Subject: **San Onofre Nuclear Generating Station Units 2 and 3**
Docket Nos. 50-361 and 50-362
Proposed Change Number NPF-10/15-551
License Amendment Request, "Reactor Coolant System (RCS) Pressure and Temperature Limits Report (PTLR)"

DESCRIPTION AND NO SIGNIFICANT HAZARDS ANALYSIS FOR PROPOSED CHANGE NPF-10/15-551 RELOCATION OF REACTOR COOLANT SYSTEM (RCS) PRESSURE AND TEMPERATURE CURVES FROM THE TECHNICAL SPECIFICATIONS TO A PRESSURE AND TEMPERATURE LIMITS REPORT (PTLR) San Onofre Nuclear Generating Station Units 2 and 3

~~FIGURE 3.4.3-4~~

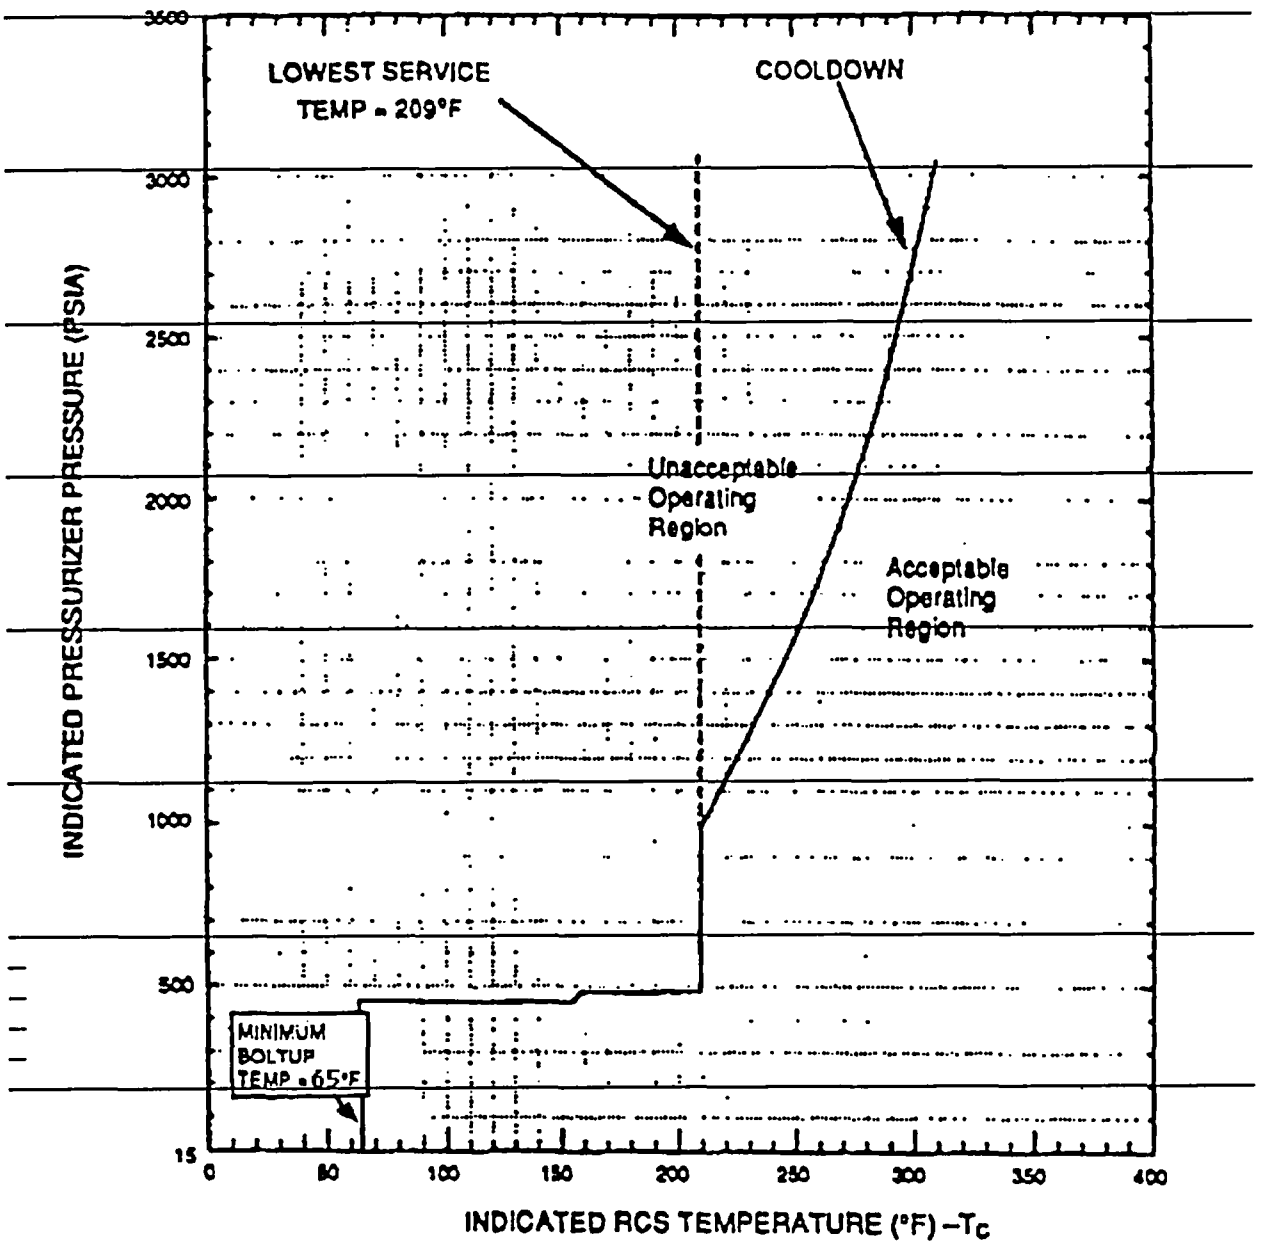
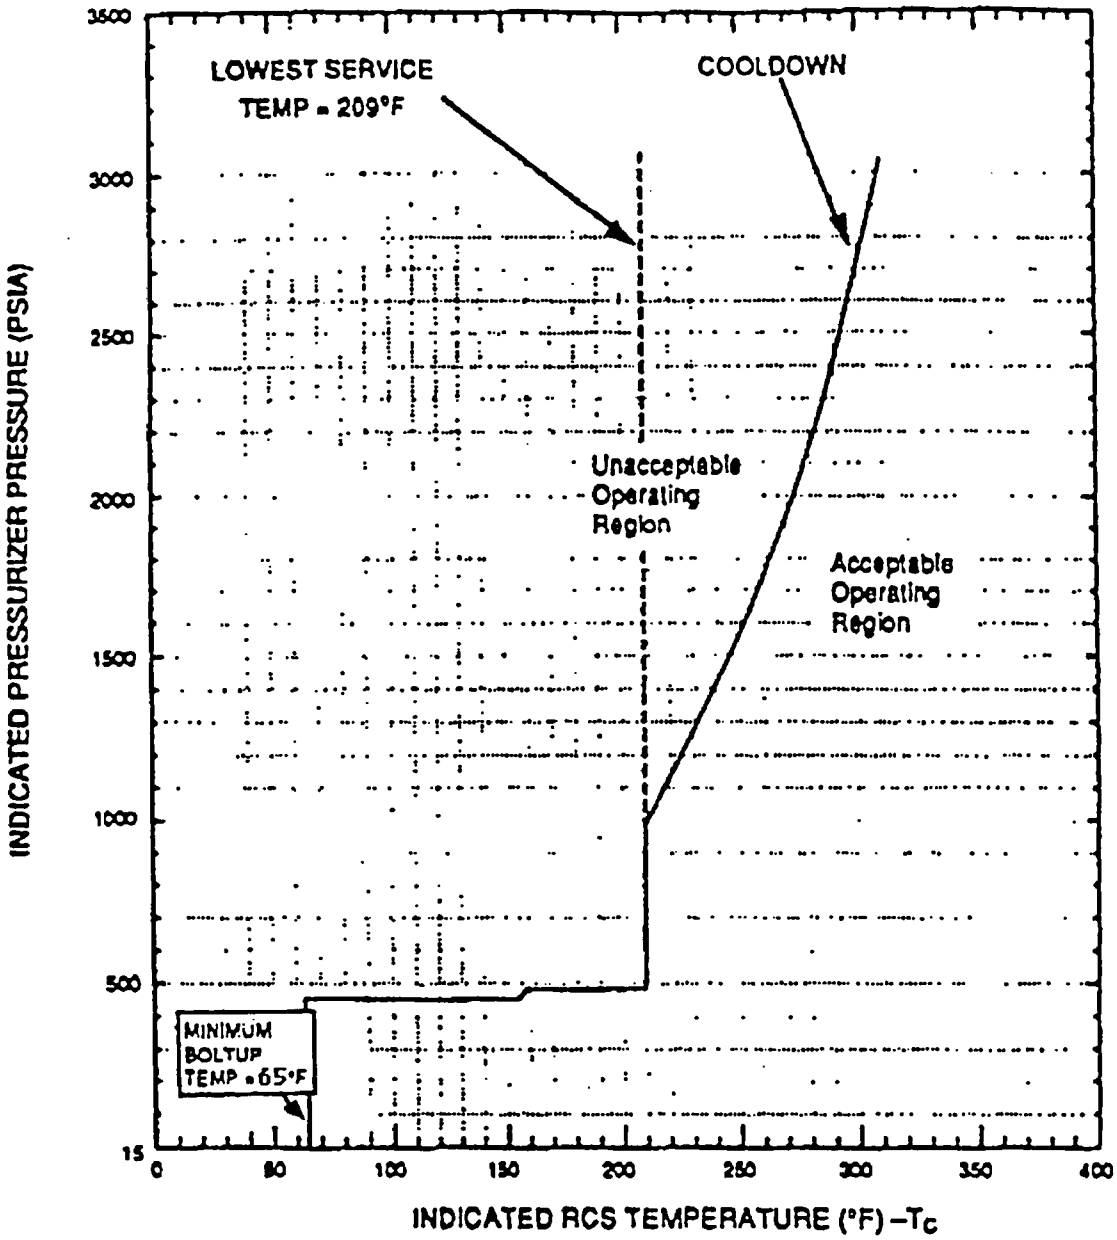
FIGURE 3.4.3-4
DELETED

~~FIGURE 3.4.3-5~~

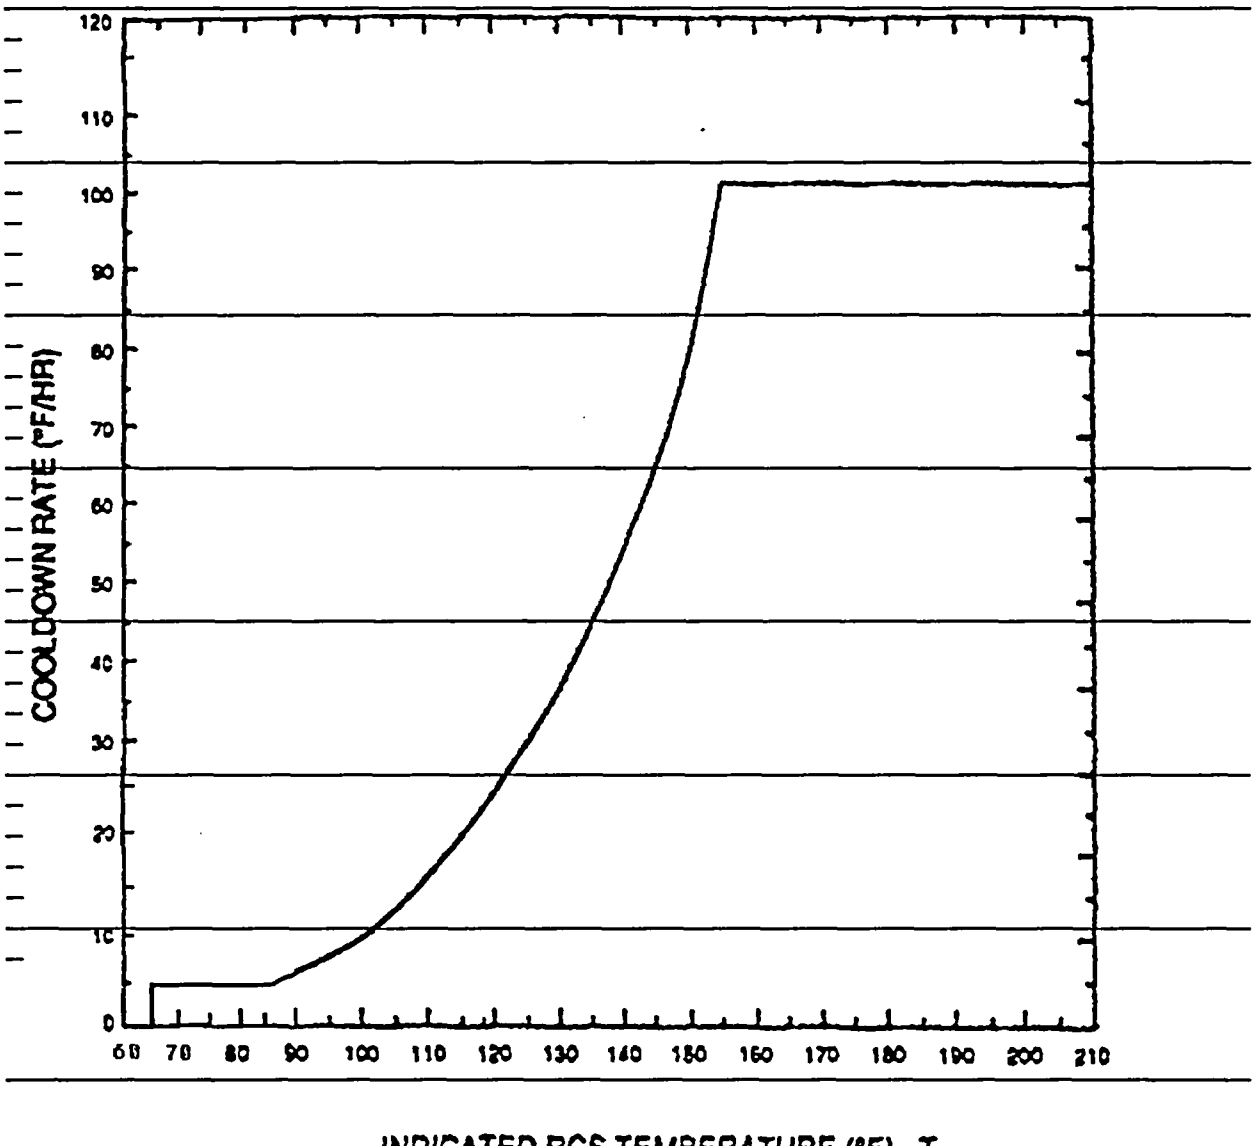
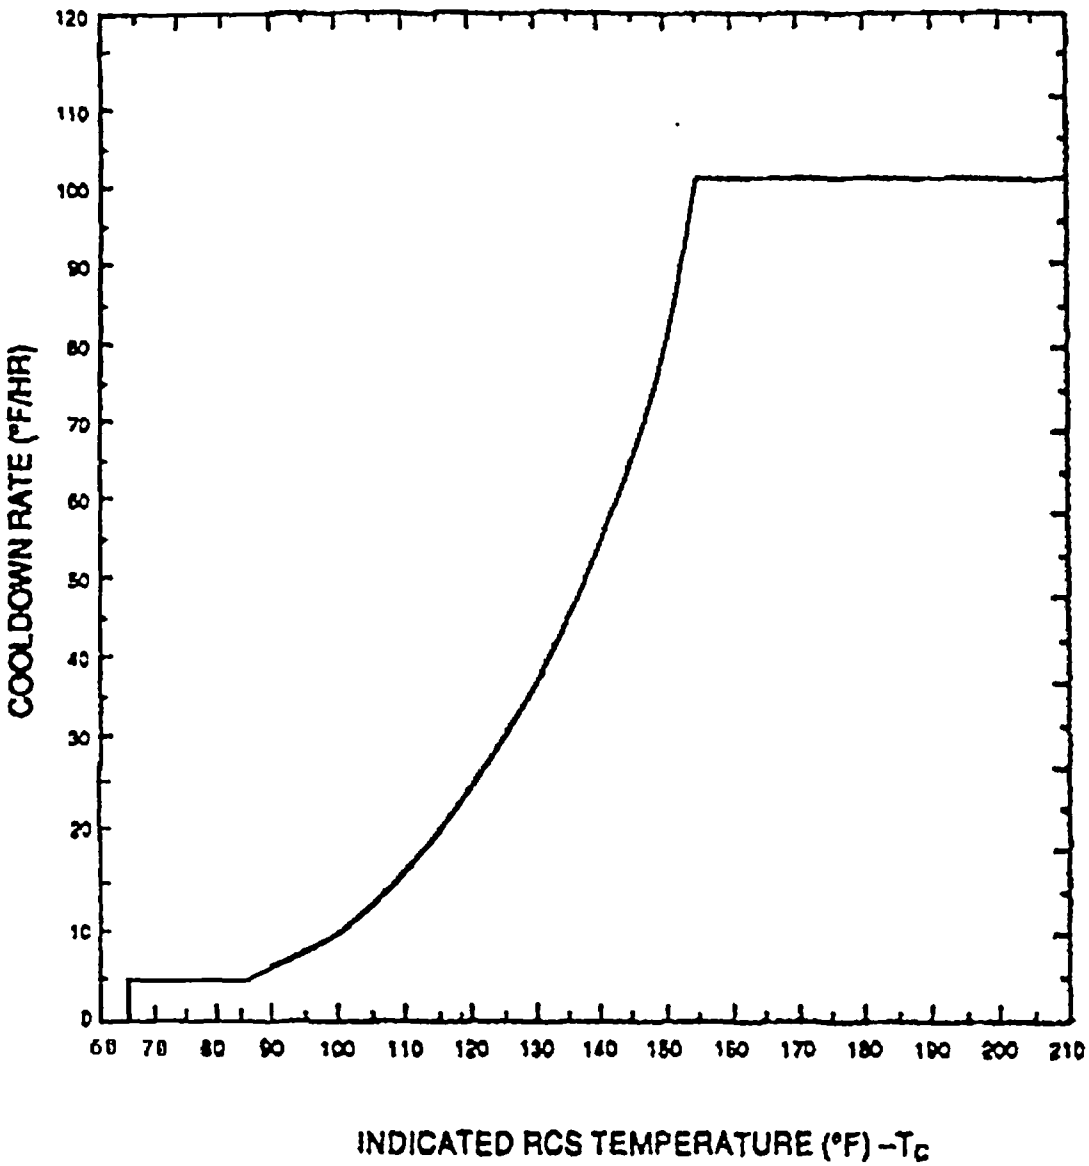
FIGURE 3.4.3-5
DELETED
